DR family interoperability, signal detect and average power limits

Piers Dawe, Nvidia

Introduction

Transmit power map for 400GBASE-DR4

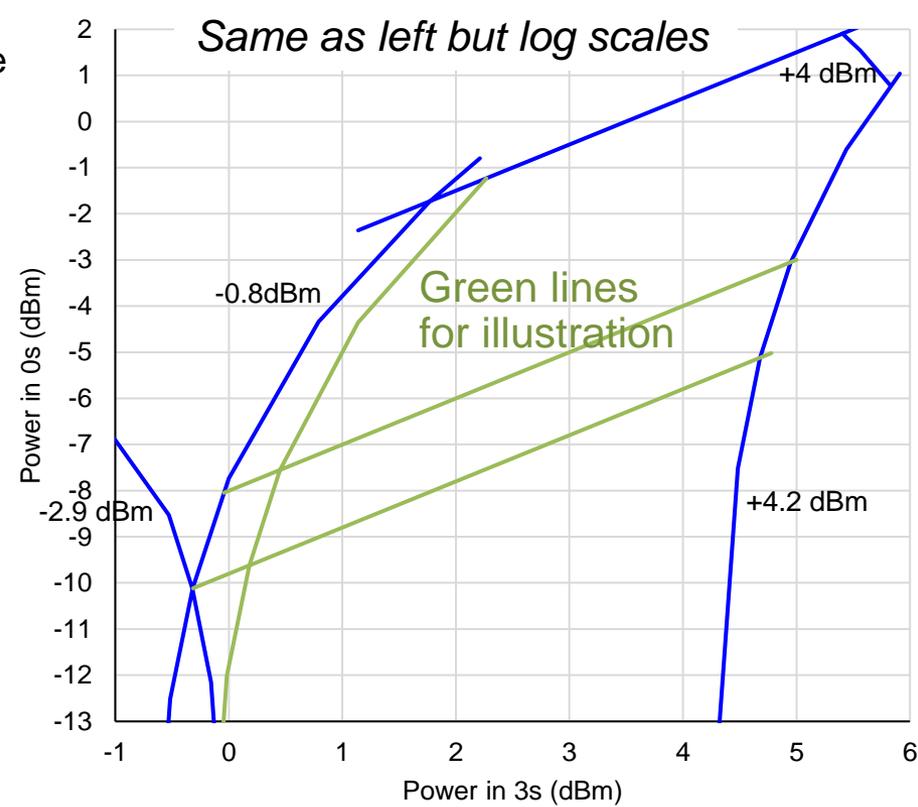
- DRn transmitter setup is defined by 5 limit lines:
- OMA min* and max, average power min and max, extinction ratio min (no max)
- * OMA min depends on TDECQ

Transmit power map for 400GBASE-DR4

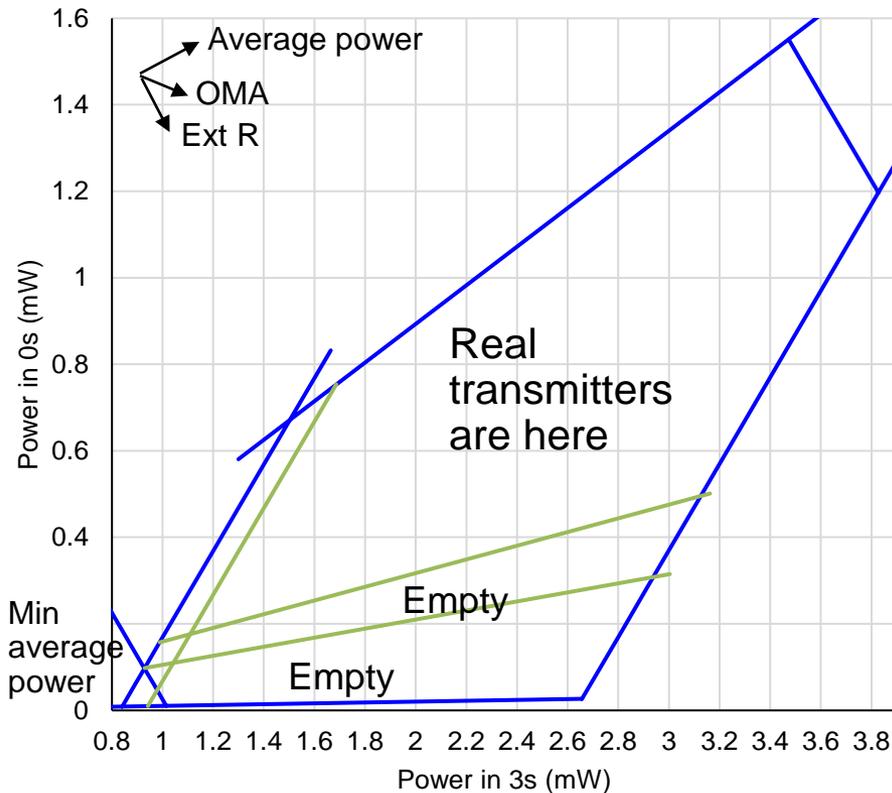
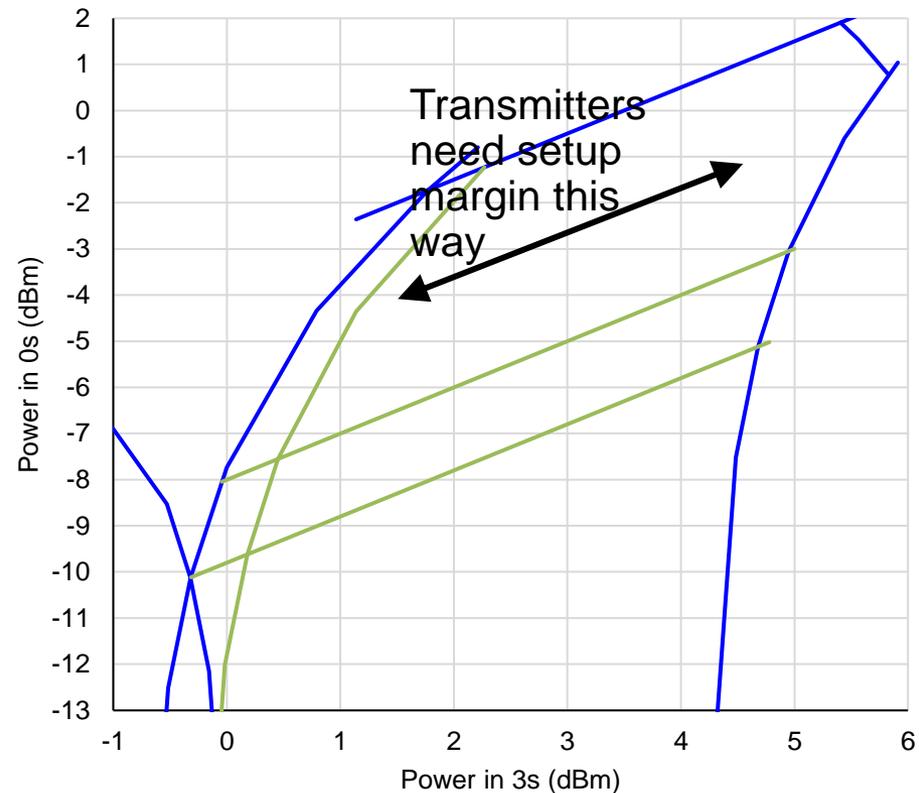
- PAM4 links don't get a strong benefit from high extinction ratio
- Most PAM4 transmitter technologies struggle to deliver very high ext. R
- The minimum average power spec has no effect on real transmitters
- If transmitters were <8 dB ext. R, it could be moved up 0.5 dB
